San Francisco Bay Regional Water Quality Control Board

Subject: Report of December 7, 2018, Inspection and Notice of Violations of the Industrial Stormwater General Permit and Technical Report Requirement, Stevens Creek Quarry, Inc., 12100 Stevens Canyon Road, Cupertino, Santa Clara County

**STEVENS CREEK QUARRY, CUPERTINO
INSPECTION REPORT**

Map 1 – Site Map of the Middle and Lower Quarry Floors (from November 2018 SWPPP)

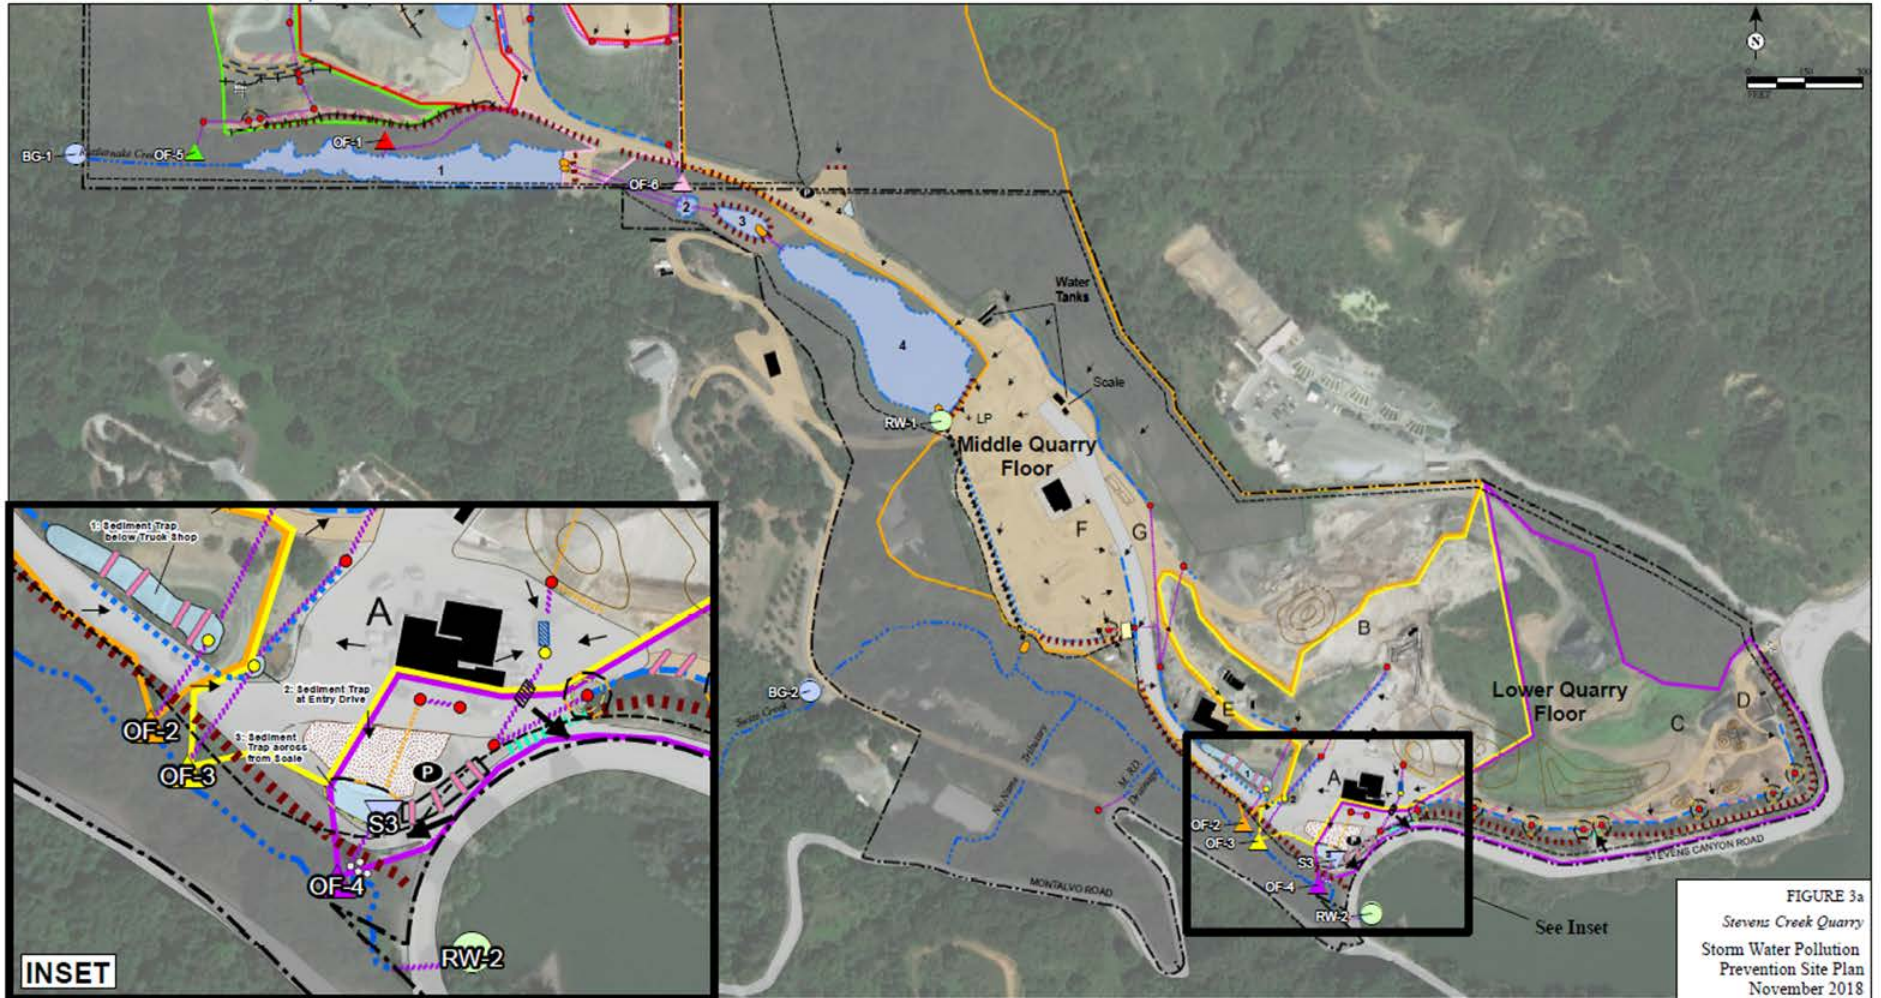
Update the SWPPP BMPs to provide an effective combination of erosion and sediment controls in the Lower Quarry Floor. In the Lower Quarry Floor, Area C, staff observed lack of containment of the topsoil piles and the dirt road, which is an ongoing violation of Permit sections X.H.1.d, Material Handling and Waste Management, and X.H.1.e, Erosion and Sediment Controls. Staff also observed evidence of material being tracked offsite, a violation of Permit section X.H.1.a, Good Housekeeping. In the debriefing meeting after the December 7, 2018, inspection, the Quarry indicated that 9” wattles would be installed at the base of the topsoil piles along the road on the Lower Quarry Floor, Area C. This was completed on December 11, 2018. However, additional BMPs need to be implemented to protect the dirt road from eroding. In addition, appropriate site entrance and exit control BMPs must be installed to prevent sediment from being tracked into streets. See specific required corrective actions described in the Photo Log.

In the Lower Quarry Floor, Area C, we observed a lack of containment of the topsoil piles and a lack of effective erosion and sediment controls on the dirt road, which is an ongoing violation of Permit sections X.H.1.d, Material Handling and Waste Management, and X.H.1.e, Erosion and Sediment Controls (Photographs 3 and 5-6). We also observed evidence of material being tracked offsite, a violation of Permit section X.H.1.a, Good Housekeeping.

Map 2 – Site Map of the Upper Quarry Floor (from November 2018 SWPPP)

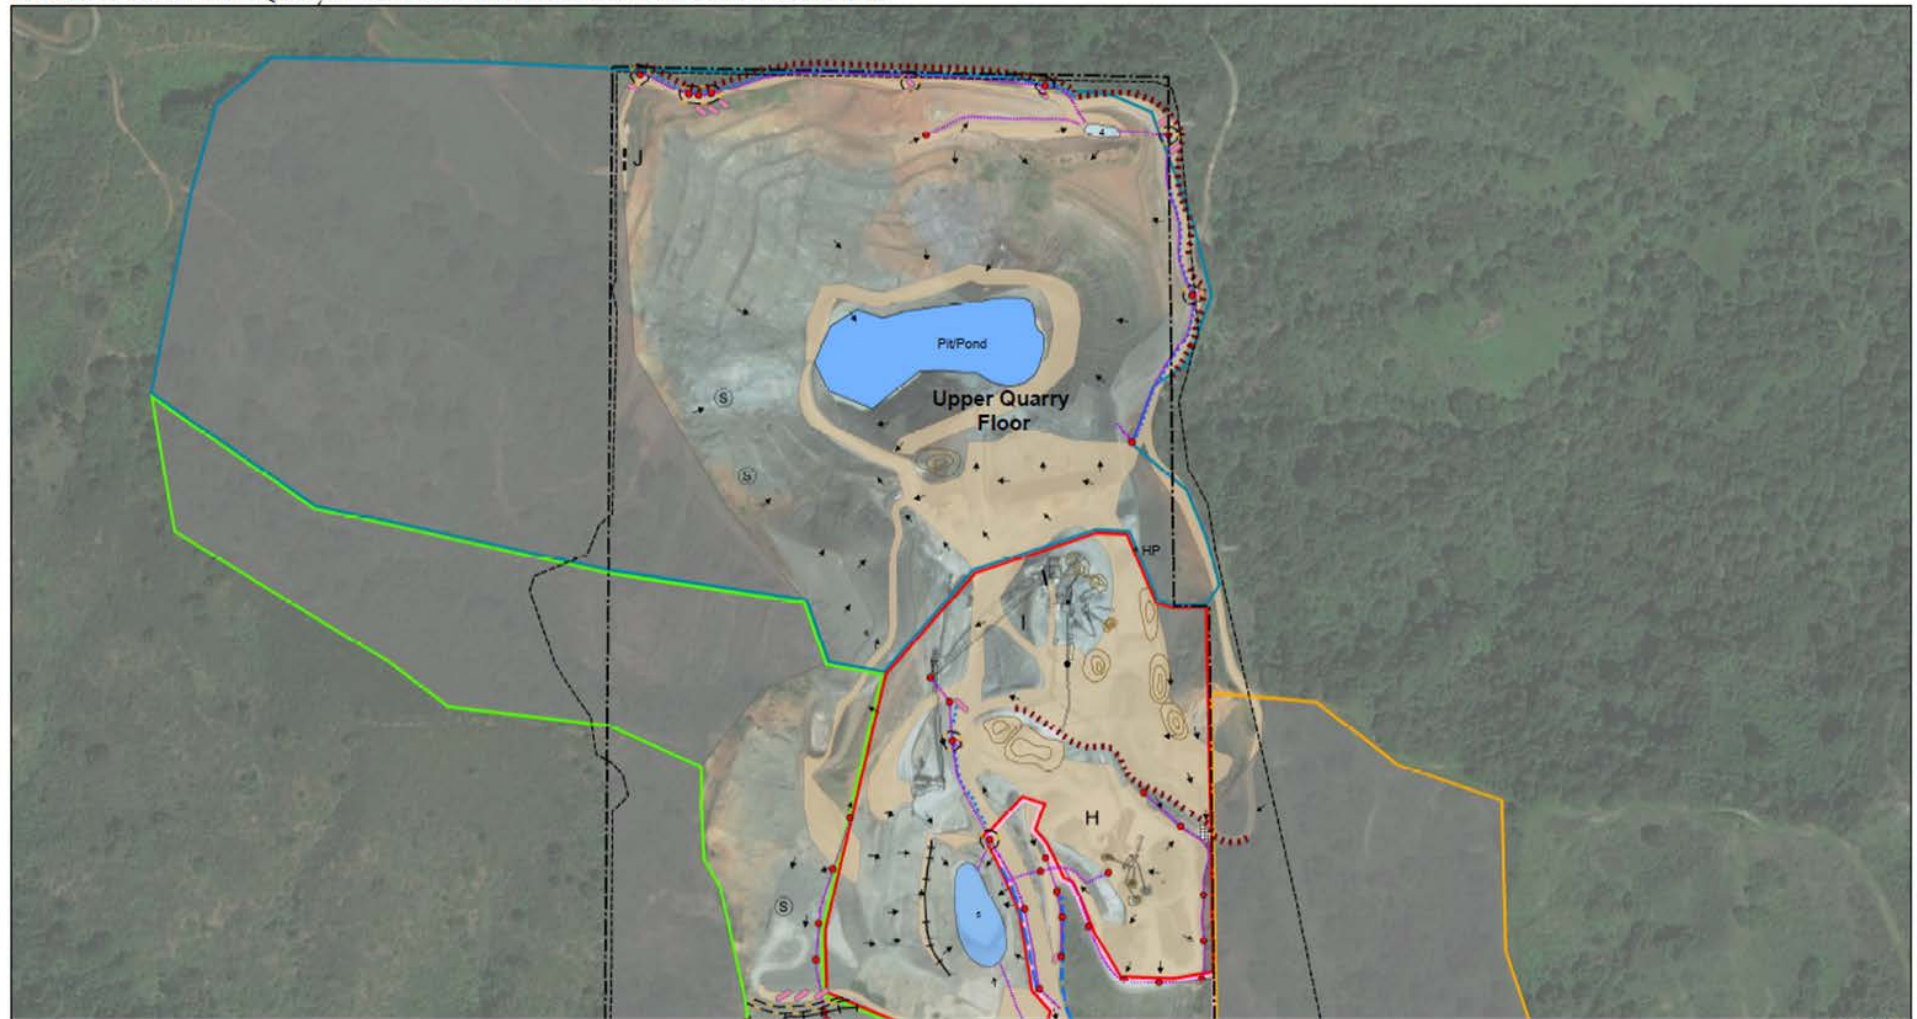
The Quarry modified the drainage areas in the Upper Quarry Floor area as described in the November 2018 SWPPP. We observed that maintenance work had been done on Sediment Pond No. 5 (Photograph 7) and a floating well pump was installed to pump water from Sediment Pond No. 5 to the Pit Pond in the Upper Quarry Floor (Photograph 8). Sediment Pond No. 5 is reported to have a capacity of 15 times the 85th percentile storm event (calculations provided in November 2018 SWPPP, Appendix F).

Sediment Pond No. 6, which had been used for runoff detention in the Upper Quarry, was no longer present, and the November 2018 SWPPP no longer shows that pond. We observed that the area north of former Sediment Pond No. 6 location and north of the Rock Plant had been regraded to direct all flow towards the Pit Pond (Photograph 8). We were told by Mr. Voss that drainage to the Pit Pond does not discharge offsite, and either infiltrates or evaporates. These changes decreased the areas draining to Outfall Nos. 1 and 5.
